A117.1 draft for Supplement 1 for the 2017 ICC A117.1

6-90-2021 AM – this whole section is new text. Revisions from the public comments received are shown in legislative text. At this time, comments are limited to revisions.

**SECTION 613
ADULT CHANGING STATIONS**

Figure 613.4

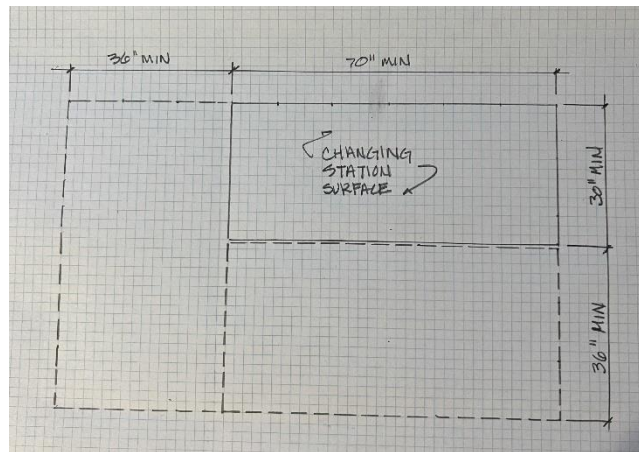
613.4.4 Maneuvering Clearances. Maneuvering Clearances at the adult changing surface and complying with Sections 613.4.4.1 and 613.4.4.2 shall be provided. adjacent to the changing surface, and Such maneuvering clearances shall be measured ~~when~~ where the adult changing surface are is in the operational position.

613.4.4.1 Side maneuvering clearance. A 36-inch (914mm) deep minimum side maneuvering clearance at the adult changing surface shall be provided along the open long side of the changing surface.

Exception: In the raised position, the side rail shall be permitted to overlap the side clearance.

613.4.4.2 End maneuvering clearance. A 36-inch (914mm) wide minimum end maneuvering clearance at the adult changing surface shall be provided along the depth of one end of the changing surface. The width of the end maneuvering clearance shall extend the depth of the changing surface and the side maneuvering clearance.

1. A 24-inch (610 mm) wide minimum end maneuvering clearance shall be permitted where a clear floor space complying with Section 305.3 is provided within the room beyond the maneuvering clearances for the changing surface.
2. Where installed in locations specified in Section 613.2.3, end maneuvering clearances complying with Section 613.4.4.2 is not required.

Size and maneuvering clearances at the adult Changing surface ~~and clearances~~
